From: Greg Sullivan [greg.sullivan@brockwayeng.com]
Sent: Monday, February 24, 2014 12:55 PM
To: Jordan, Blake; Palmer, Cherie
Subject: Koompin Place of Use 1 of 2
Attachments: Koompin 2013 POU update.jpg; Irrigation_POU_2014.dbf; Irrigation_POU_2014.sbn; Irrigation_POU_2014.sbx; Irrigation_POU_2014.shp; Irrigation_POU_2014.shx; Irrigation_POU_2014.prj

Due to errors on my end of things. We need to align the acres to be leased to the Water Supply Bank and the POU of 35-14308. I am providing an updated aerial map and shape files with the corrected POU of 35-14308 and the large POU for the remainder water rights owned by KBCP and KBC farms.

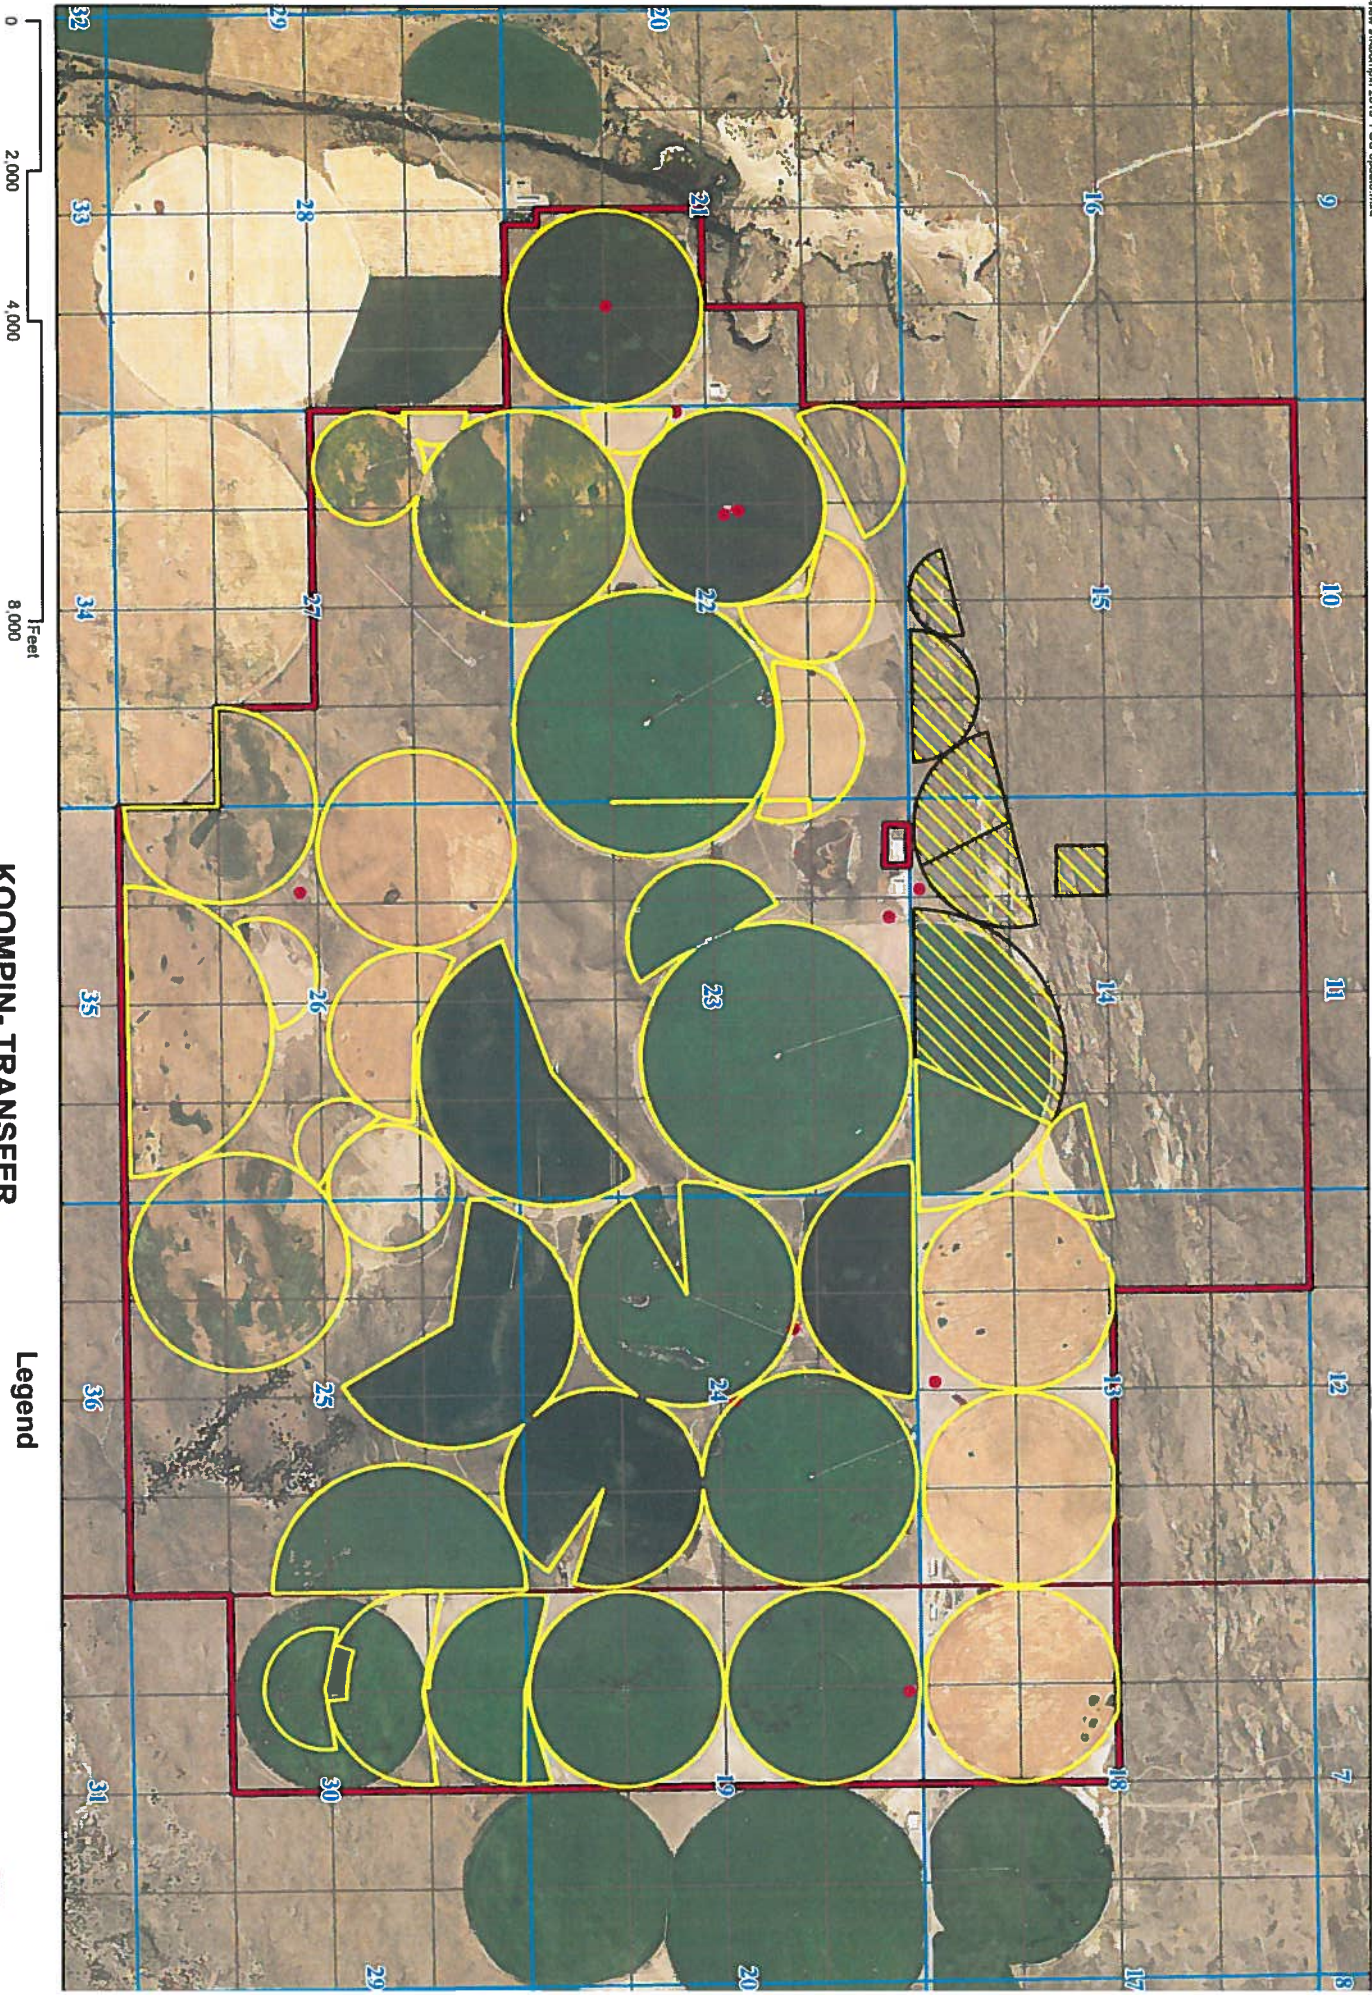
After reviewing KBC's proposed irrigation place of use for the 2014 irrigation season I noticed that there are two sets of water rights with different irrigation places of use within the 6154.0 acre PPU. Water rights 35-7275, 35-7399, 35-13397, 35-13382, 35-13384, 35-13385, 35-13386, 35-13388, 35-13390, 35-13915, 35-13916, 35-13387, 35-13899, 35-13900, 35-4702, 35-13409, 35-13381, 35-13412, 35-13389, 35-7401, 35-13410, 35-13411, 35-13413, 35-13415, 35-13414, 35-2274, 35-7390, 35-7630, 35-2432C, 35-7391C, 35-7863, 35-13905, 35-13906, 35-2172, 35-13703, 35-13897, 35-13898 and 35-14213 when combined are limited to a specific 3434.0 acre place of use within the 6154.0 acre PPU. Water right 35-14308 is limited to a specific 208.0 acres within the 6154.0 acre PPU. Since these groups of water rights are conditioned to specific acres within the PPU and have different combined acre limits we need to keep them separate. Could you please send a map and if possible a shapefile that has a proposed irrigation place of use of 3434.0 acres (large grouped water rights) and a separate shape for the 208.0 acre (35-14308) proposed irrigation place of use?

I also noticed that the authorized point of diversion for water right 35-14308 is only located in the SWSW of 08S, 29E, Section 14. I did not notice this point of diversion on your map. Does KBC plan on drilling this well?

The POUs of the water rights will be updated to match submitted water bank Lease and Rental applications.

I have attached a new aerial map for you that identifies the 208.0 acres from 35-14308. Water right 35-14308 is leased to the water bank currently and a portion of 35-14308 should be released this spring. However, a portion of 35-14308 will be leased to the water bank through 2016. Rental applications have been filed to make up for the acres not currently allowed to be irrigated under 35-14308 at this time.
